Access Compliance Report

Public Rights-of-Way

(Curb Ramps)

Intersection ID: 18423	Main Street: ELESSAR_PL	Cross Street: STRIDER_DR	Location: NW
ADA ID: 806C8788EC15	Ramp Type: PerpDiag	Initial Pass/Fail: Fail	Overall Compliance: No
Severity Score: 12.5			
Codes/Mitigation Info/Possible Solution		Field Measurements/Component Compliance

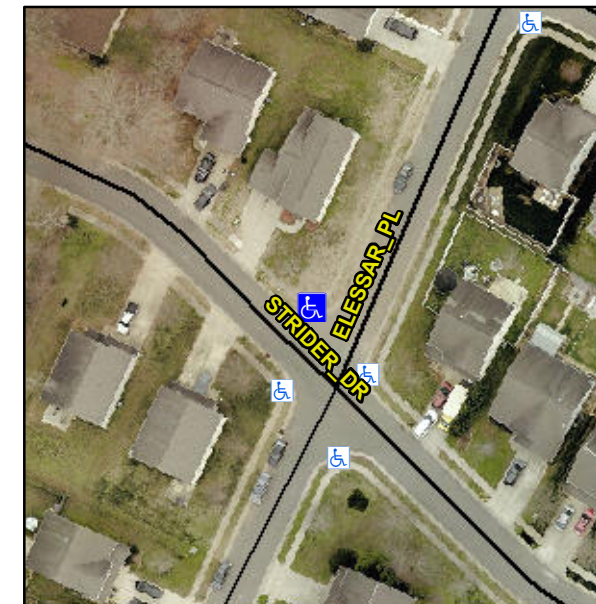
Not Found, R304.5.3

Compliance	Description	Data	Compliance	Description	Data
N/A	Ramp Length (in)	48.0	Yes	Ramp Slope (%)	6.0
Yes	Ramp Width (in)	48.0	No	Ramp XSlope (%)	5.7
N/A	Flare Type LT	N/A	N/A	Flare Type RT	N/A
N/A	Flare Slope LT (%)	N/A	N/A	Flare Slope RT (%)	N/A
N/A	Flare Traversable LT?	N/A	N/A	Flare Traversable RT?	N/A
N/A	Landing Length (in)	N/A	N/A	DWS Provided?	N/A
N/A	Landing Width (in)	N/A	N/A	DWS Contrast?	N/A
N/A	Landing Slope (%)	N/A	N/A	DWS Length (in)	N/A
N/A	Landing X Slope (%)	N/A	N/A	DWS Full Width?	N/A
N/A	Landing Curb? (Y/N)	N/A	N/A	DWS Offset (in)	N/A
N/A	Shared Landing?	N/A			
N/A	Gutter Ponding?	N/A	N/A	Gutter Slope (%)	N/A
N/A	Gutter Lip Ht (in)	N/A	N/A	Gutter X Slope (%)	N/A
N/A	Painted X Walk1?	No	N/A	Painted X Walk2?	No
	X Walk 1 Direction	To SW		X Walk 2 Direction	To SE
N/A	X Walk 1 Width (in)	N/A	N/A	X Walk 2 Width (in)	N/A
	X Walk 1 Slope (%)	2.1		X Walk 2 Slope (%)	0.5
	X Walk 1 X Slope (%)	5.1		X Walk 2 X Slope (%)	2.0

Remove & Replace Curb Ramp With Two New Directional Ramps or Equivalent.
